Cortex Apparels Ltd

Holding # 160/1, Madhabpur, Ward-01,
Kashimpur Metro, Gazipur-1349, Bangladesh
(24.007779N, 90.262224E)

26 November 2023

Observation-1: Columns appear to exceed Euler force. (Main Production Building).

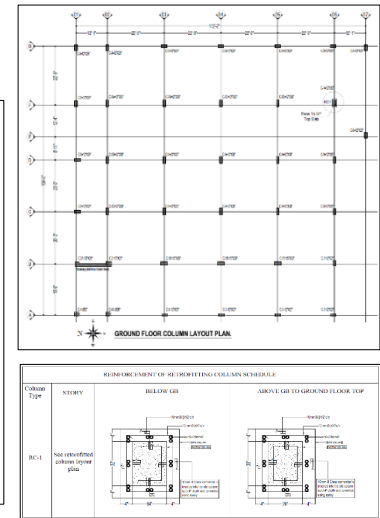
From the above table it is clear that one column is Overstressed. This column needs to be retrofitted. All other columns are safe and sound.

Description: Ground floor columns are 4.31 m in length and 300X750 mm in size. The length/width=14.36 indicate that the columns are critical for slenderness effect. Factory has proposed the retrofitting for a column at grid- F/6. The building engineer is required to check and address this issue in the design report of all the required columns.

Column details for the C5 & C6

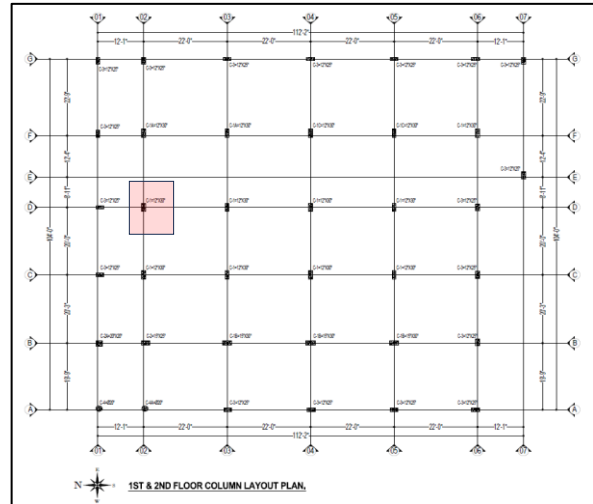
In column layout plan, Column ID-C1D has been shown at grid-D/2. But no details of the column have been provided in the column schedule. The size and shape of the C5 & C6 column do not match between as-built drawing and site condition.

63 psf has been assigned in FEA model

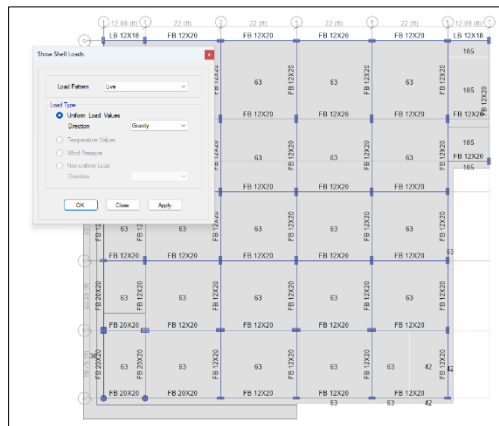
The load assignment in FEA model does not match between FEA model and provided load plan.
